ADDENDUM NUMBER 1

DATE: 12/20/2024

PROJECT: SEMCO Emergency Operations Center

ARCHITECT/ENGINEER: Anderson, Eckstein & Westrick, Inc.

A412

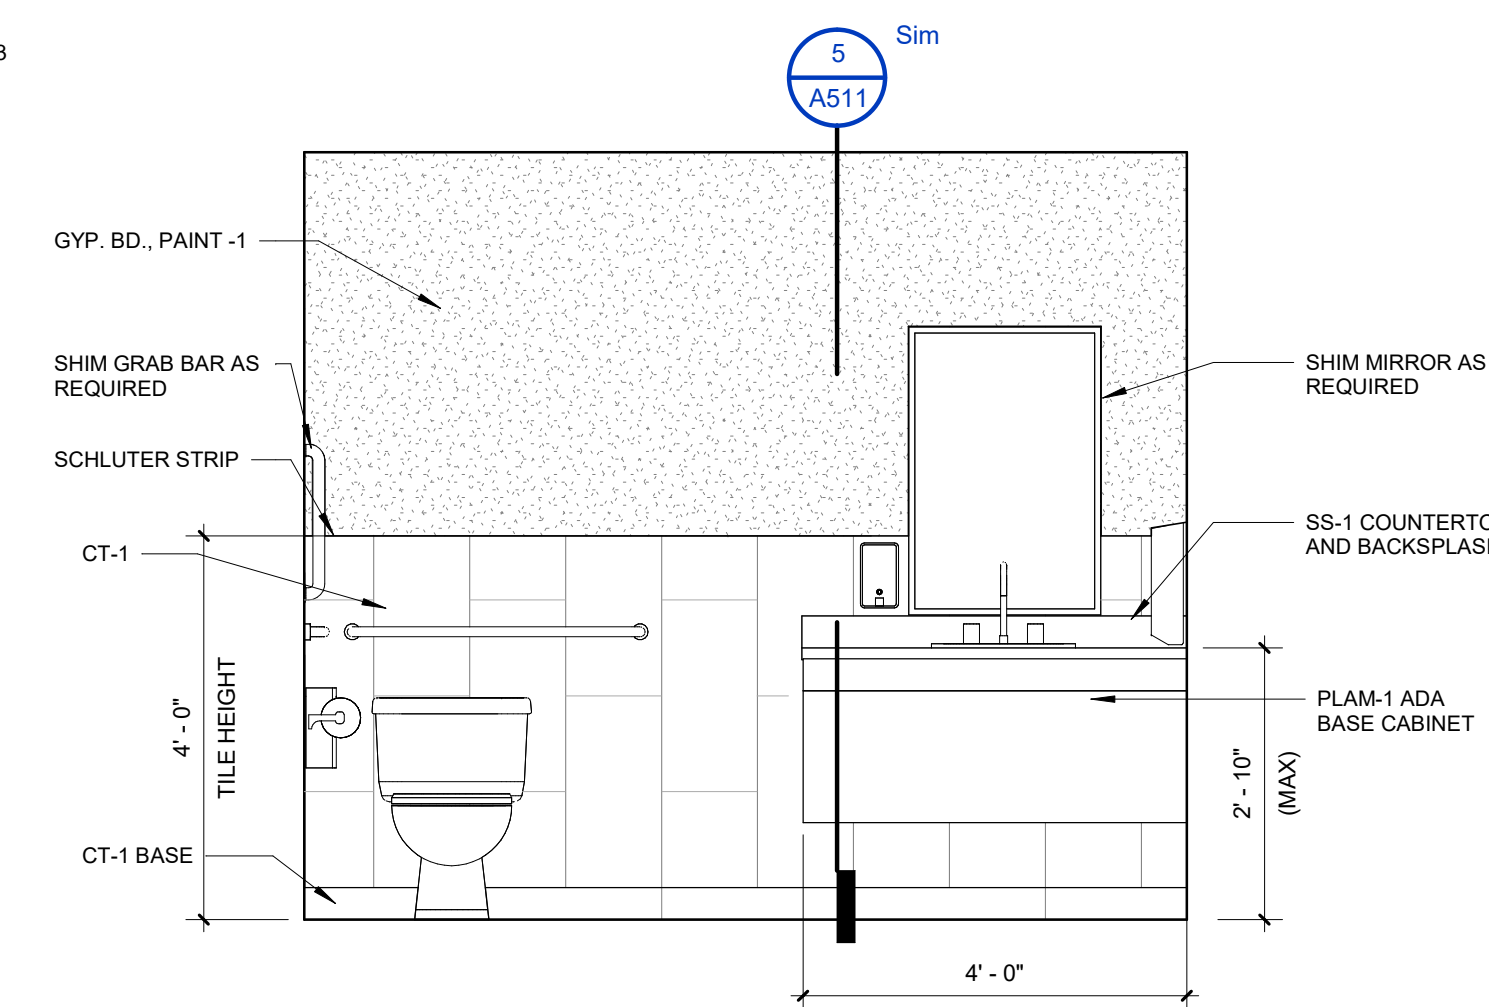
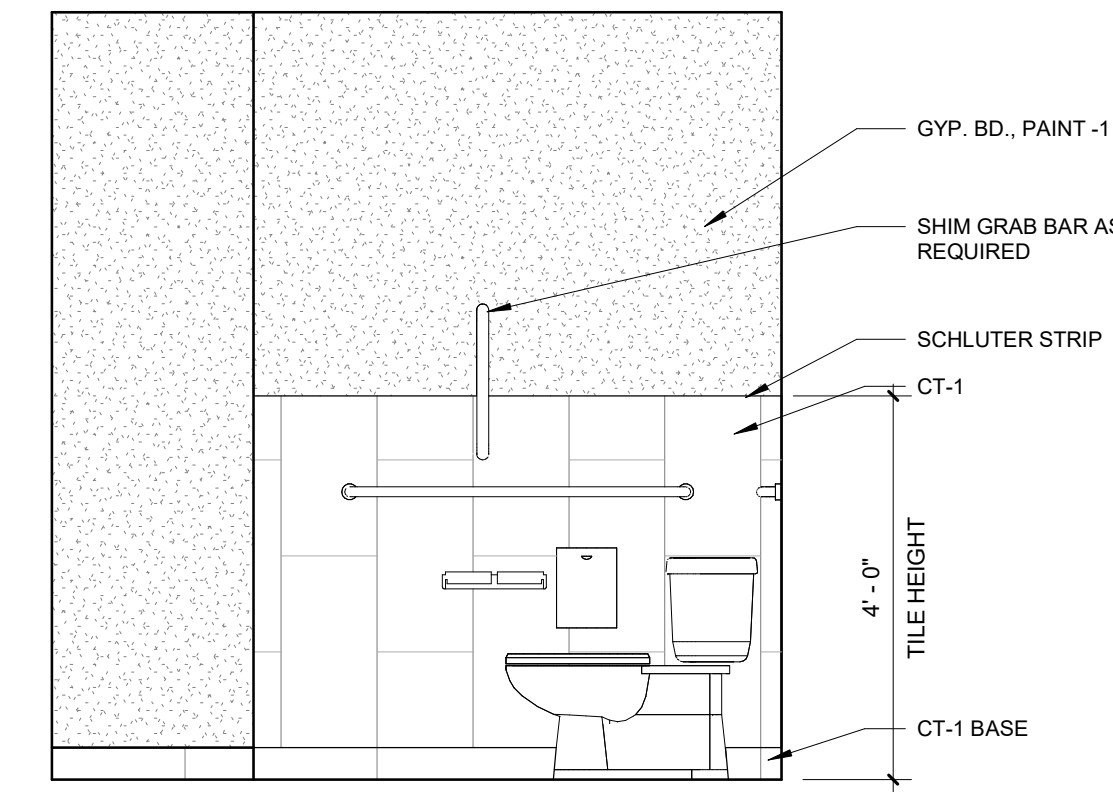
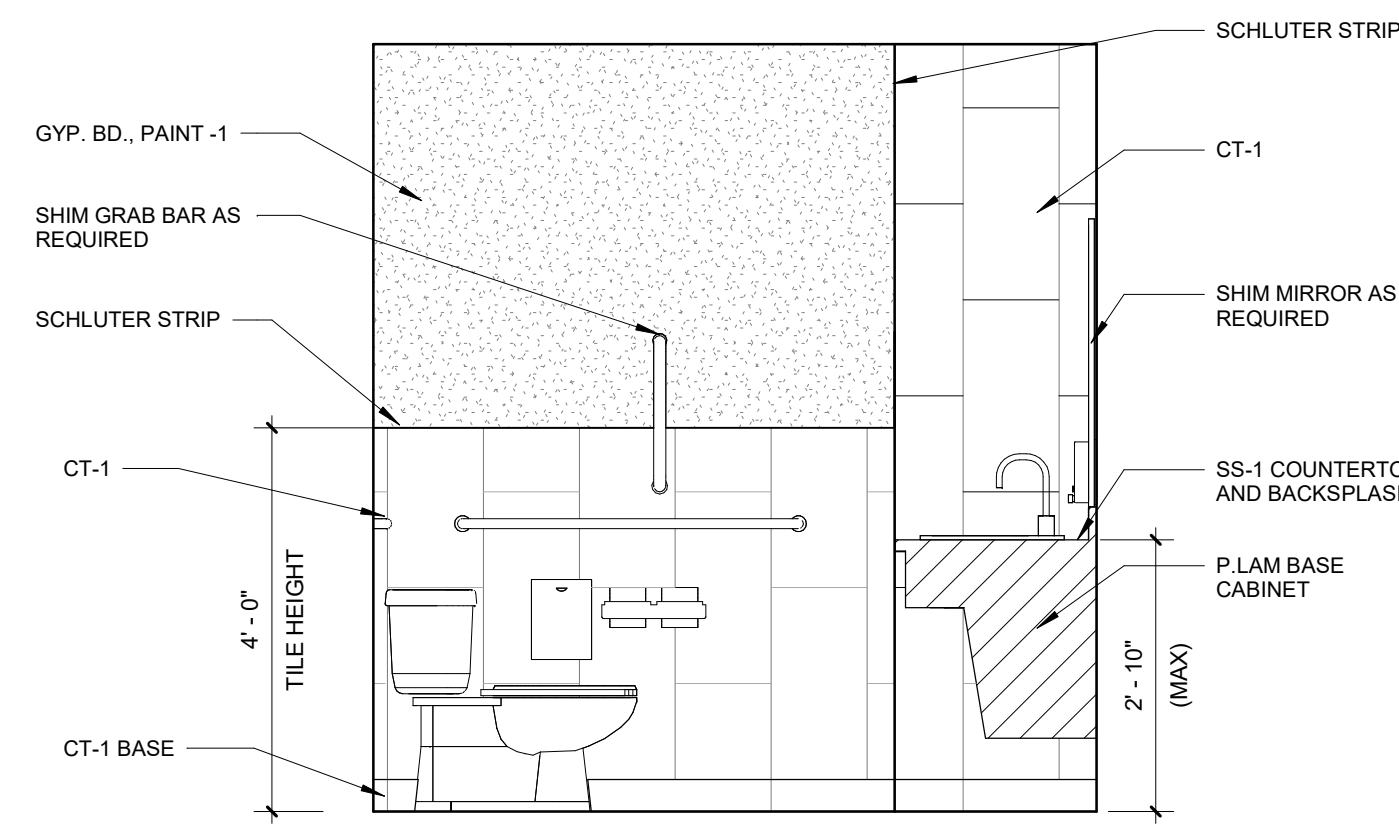
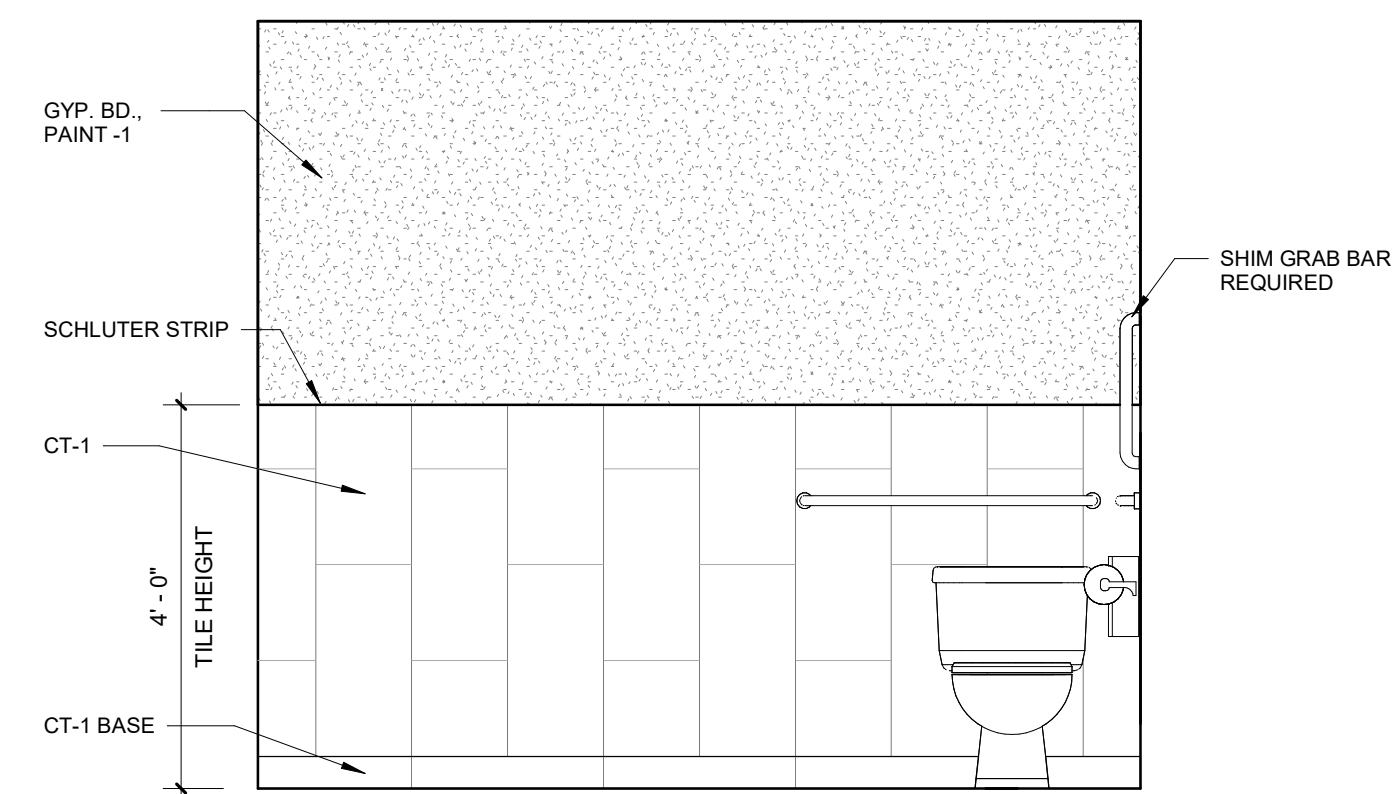
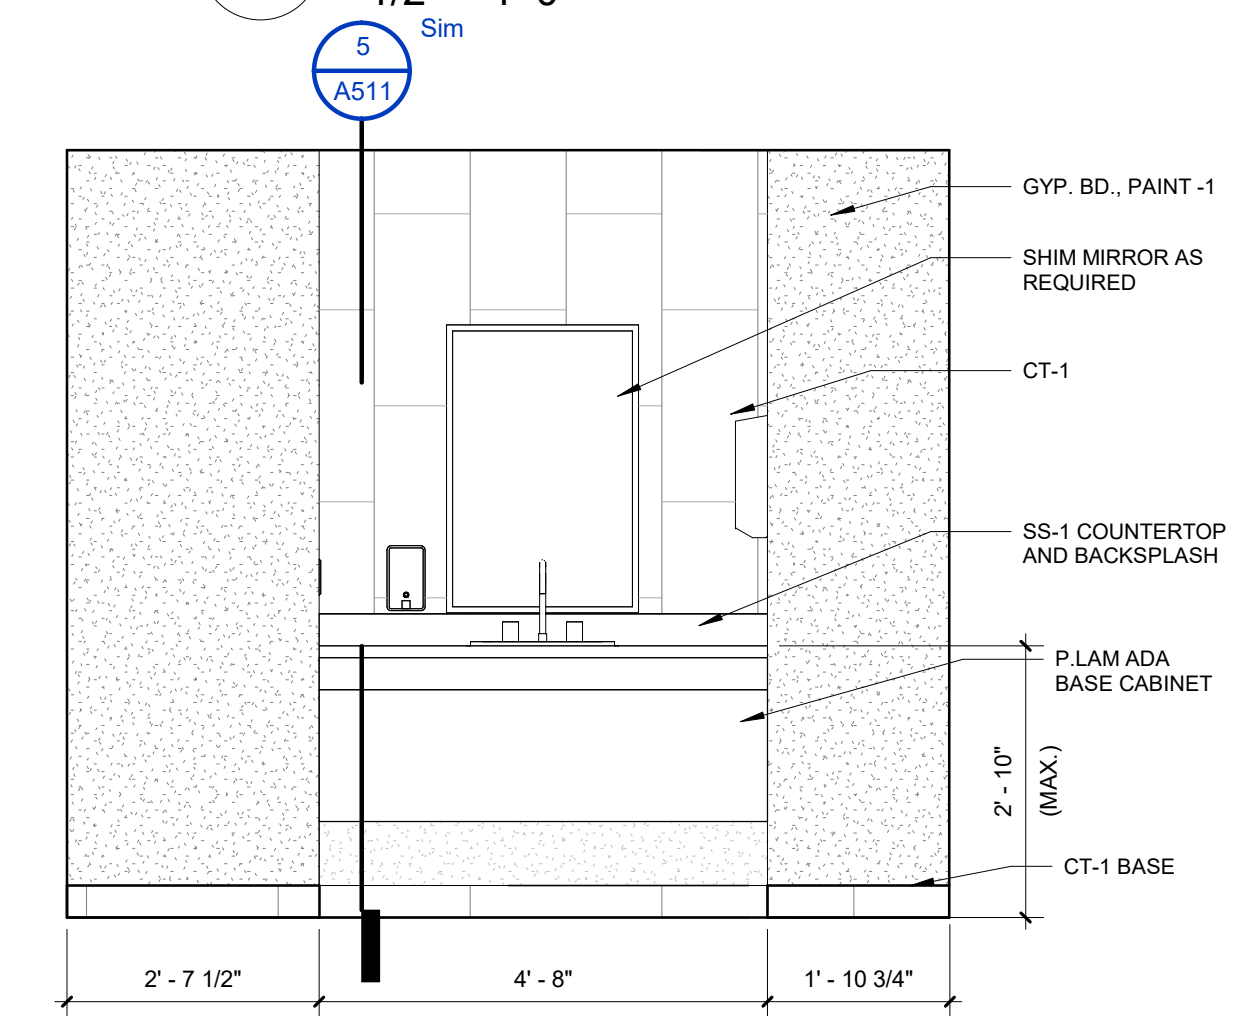
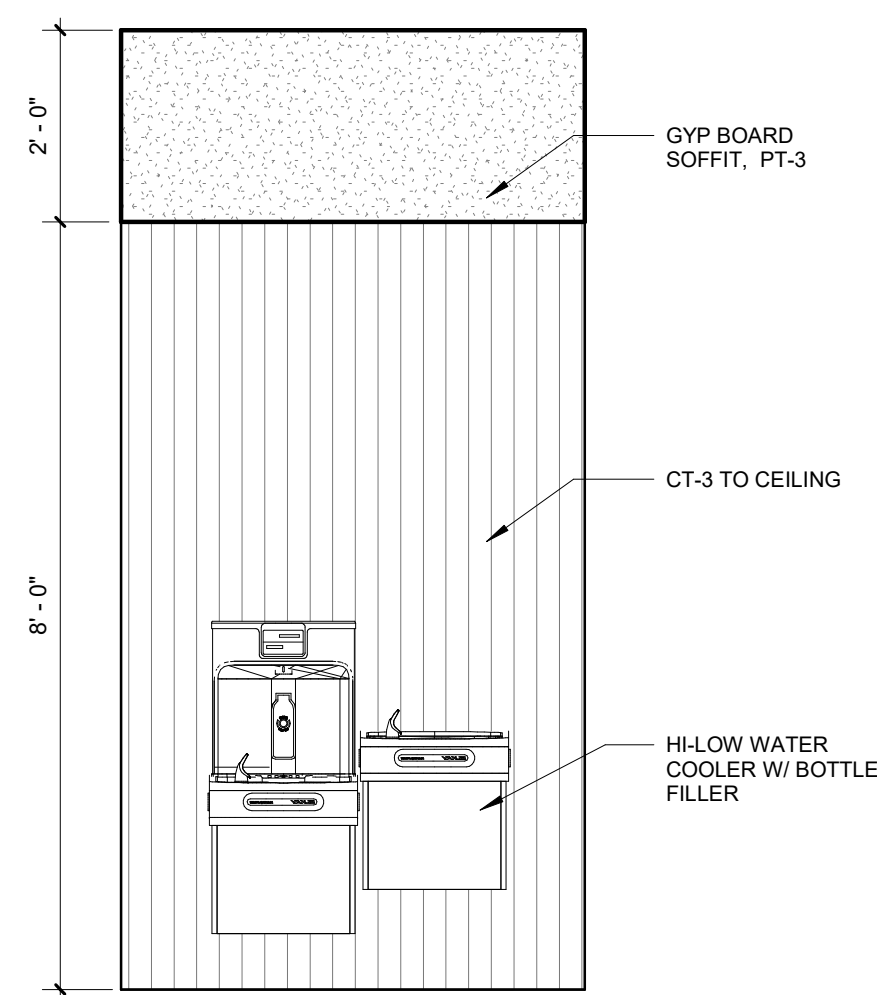
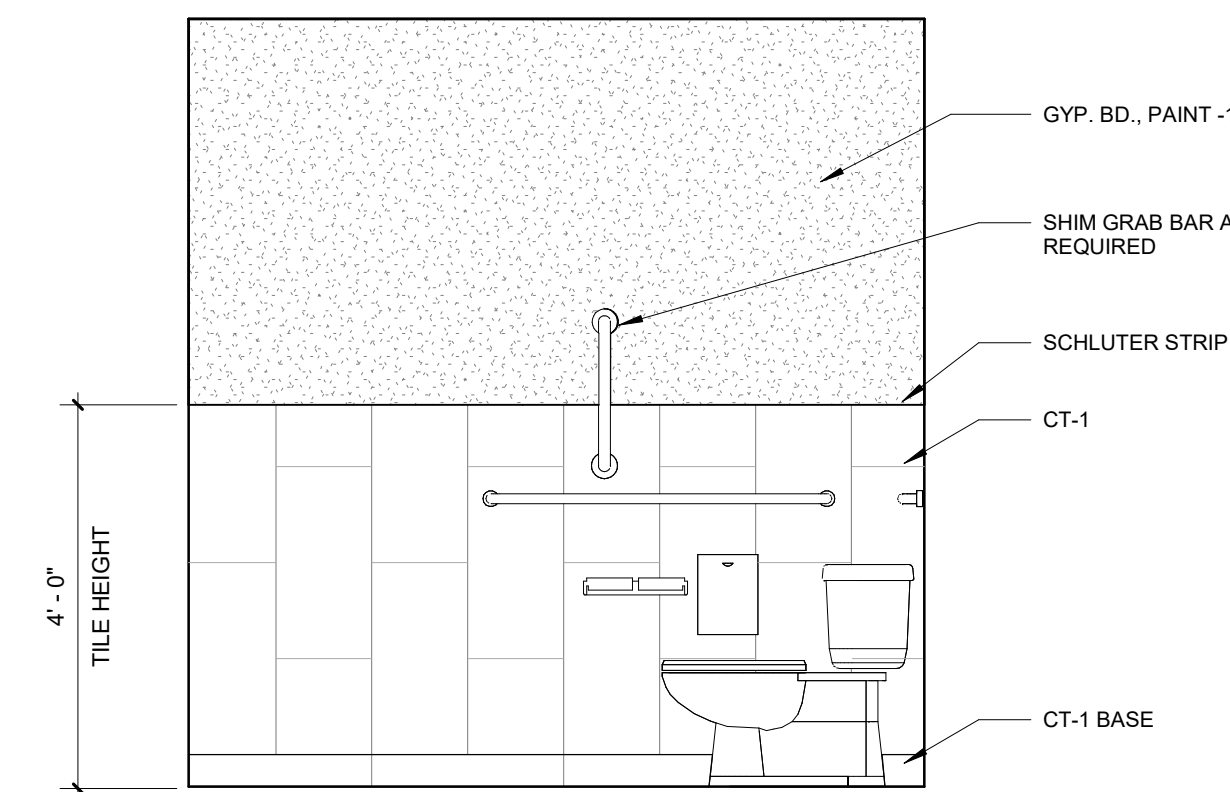
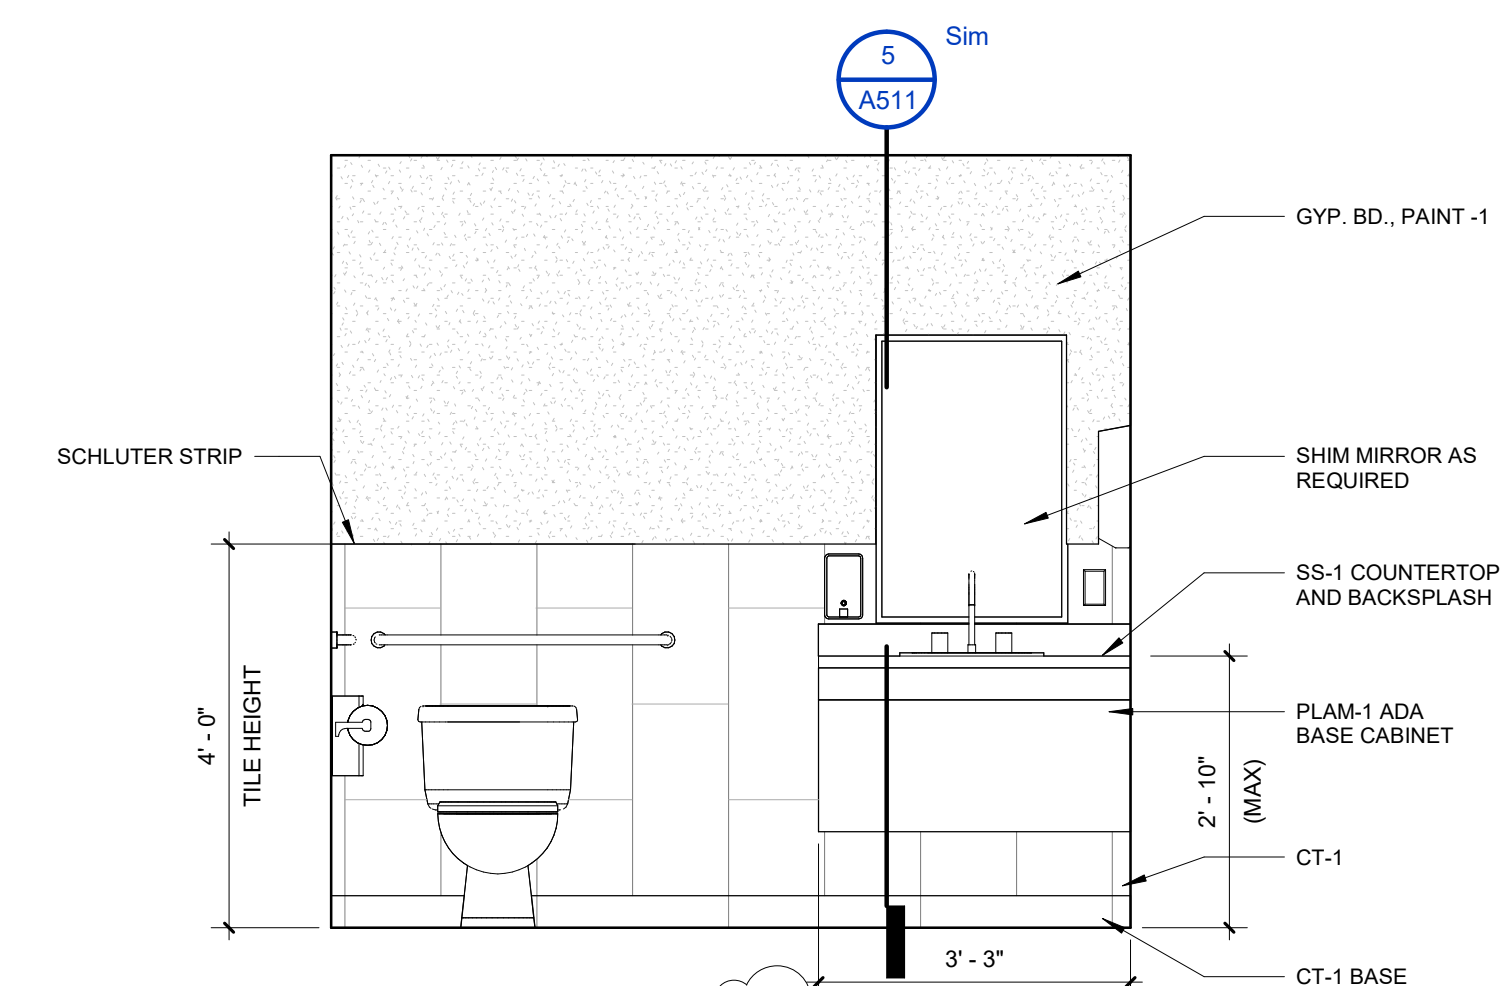
3. **Q:** Room finish schedule shows 3 Toilet rooms, 102, 107 & 114, all to have tile on all 4 walls, but elevations show only 2 wet walls to be tiled. Please clarify. Also, what about existing toilet rooms 116 & 117? They are not listed on room finish schedule, but there is an elevation showing 2 walls for room 117. Please clarify.
A: Refer to revised room finish schedule for selected walls to have tile up to 4'-0" in Toilet rooms. Interior Elevations 1 and 2 on A412 are referring to Toilet room 114, names have been revised. Toilet rooms 116 and 117 are not included in the scope of the project. The only work in Toilet Rooms 116 & 117 is replacing the floor as required for new sanitary lines, include allowance to match existing flooring.

11 GAS SUPERVISOR OFFICE DETAIL
A511 1" = 1'-0"

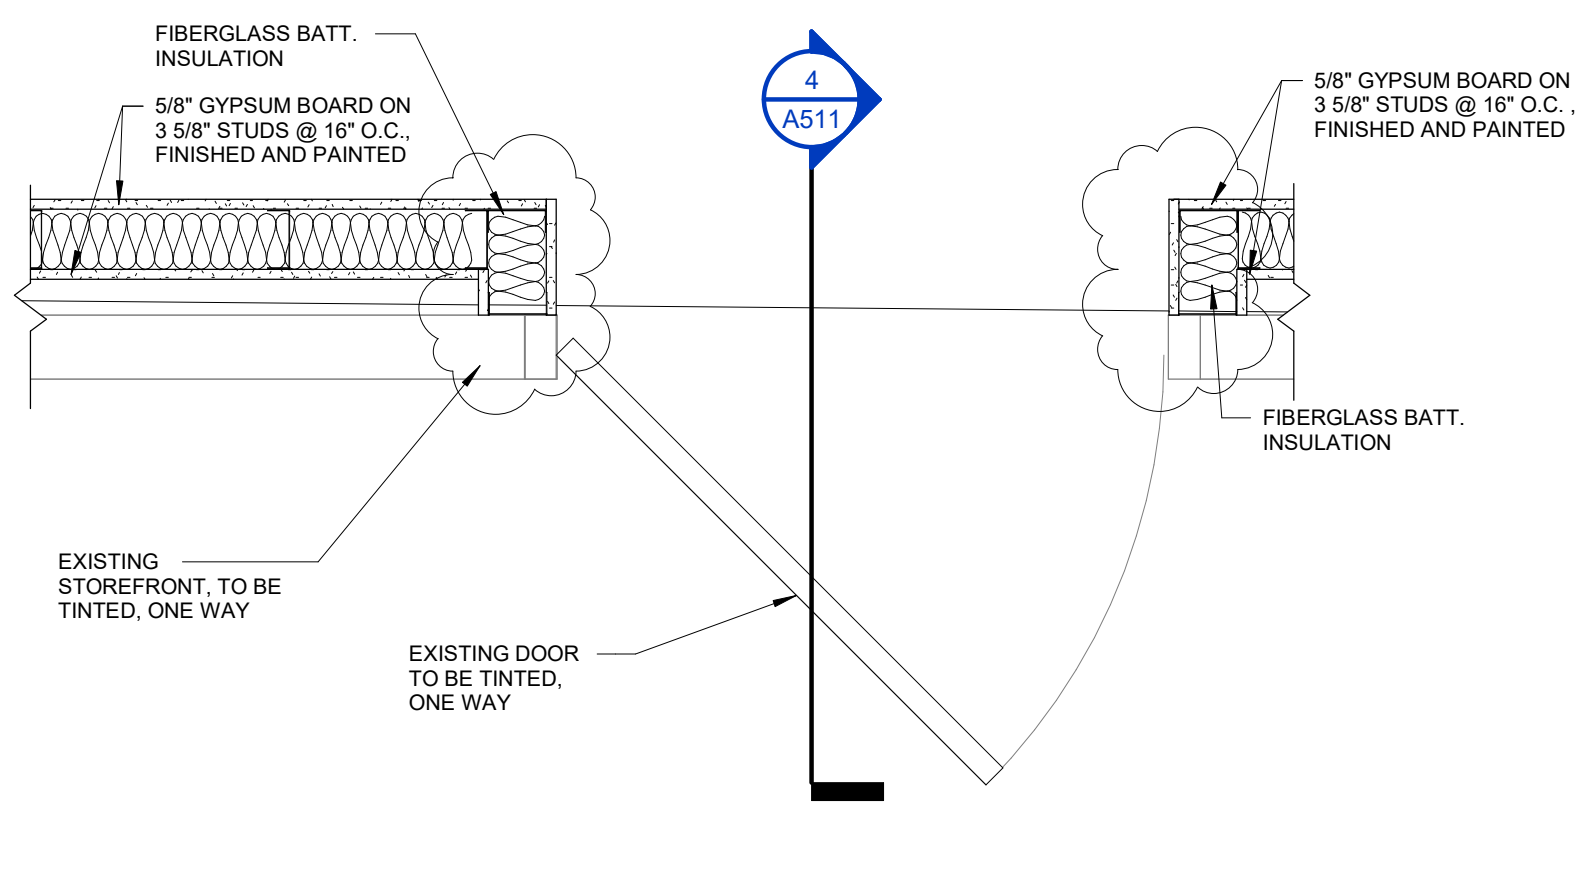
1. SHEET A101: reissued
 - a. Partition moved 2" off existing curtain wall
 - b. Added UL Listing U301 for partition type A1
 - c. Added Gas Supervisor Office Callout 11/A511
 - d. Added Fatigue Room Call out 10/A511
2. SHEET A301: reissued
 - a. Partition moved 2" off existing curtain wall
 - b. Detail 2 added dimensions for window tint
3. SHEET A412: reissued
 - a. Toilet 109 revised to Toilet 107
 - b. Toilet 117 revised to Toilet 114
4. SHEET A511: reissued
 - a. Detail 3 partition moved 2" off existing curtain wall
 - b. Detail 4 partition moved 2" off existing curtain wall
 - c. Detail 10 added
 - d. Detail 11 added
5. SHEET A611: reissued
 - a. Revised Toilet room wall finishes
